1111 E. UNION ST.
DRB RECOMMENDATION MEETING

SEPTEMBER 2, 2009

Union &
Madison, LLC

MASSING PRESENTED TO EDG BOARD

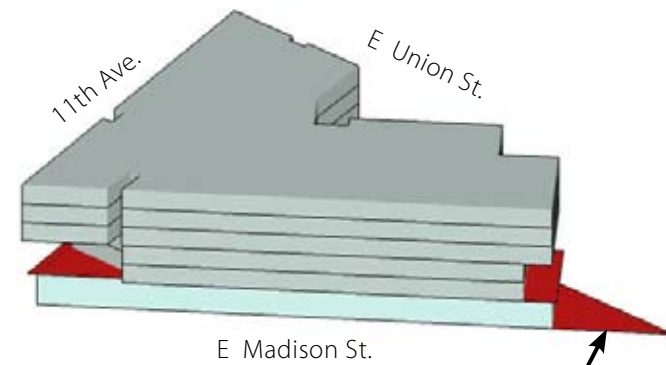
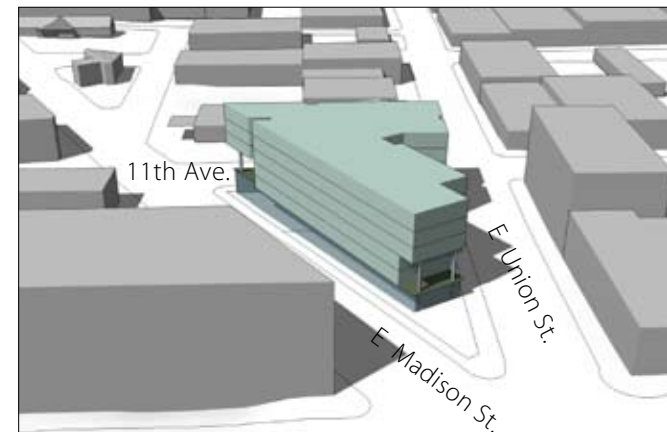
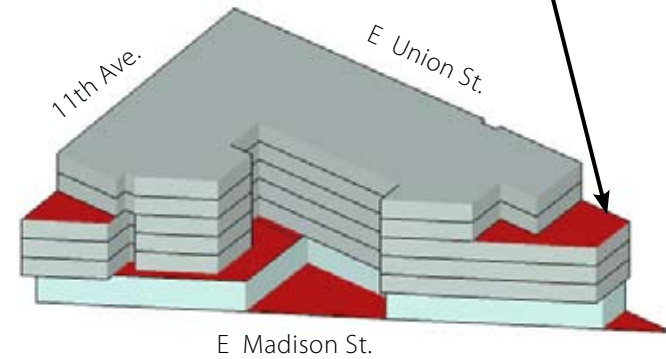
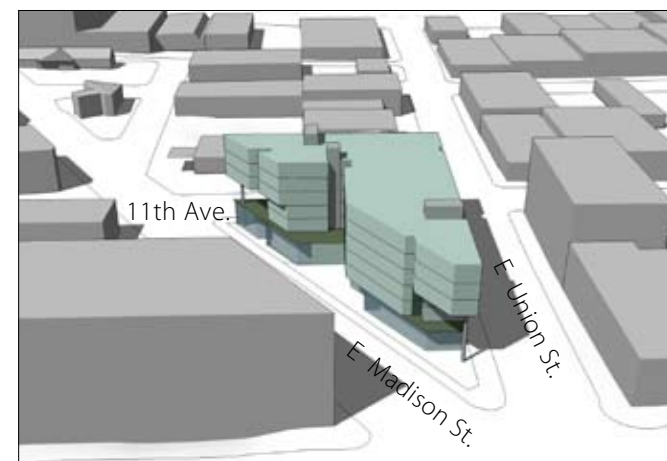
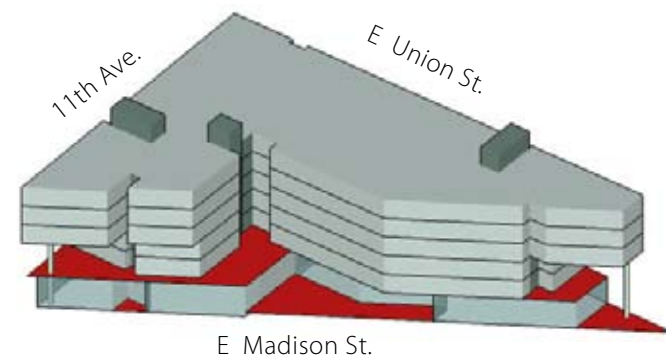
EDG BOARD RECOMMENDATIONS:

1. Strengthen project massing with a stronger urban edge along E Madison St.
2. Location of residential open space should take into consideration noise of E Madison St.

3. Encourage developing 11th Ave as the strong pedestrian connection with human activity.
4. Acknowledged Union St was the most appropriate location for the garage entrance and encouraged shifting the garage entrance so that it did not face the entry of the Union Coop.

5. Encouraged requesting a Design Departure for the driveway width.
6. The corners could be more anchored, particularly the corner at 12th Ave and E Madison St and the massing could express the triangular geometry of the site.

7. The soffits will become a "fifth façade" and the materials chosen will be important.
8. Enhance the landscaped pedestrian connection from Seattle University to Cal Anderson Park. The project should take advantage of the enlarged curb bulbs at the site as further opportunity for landscaping.
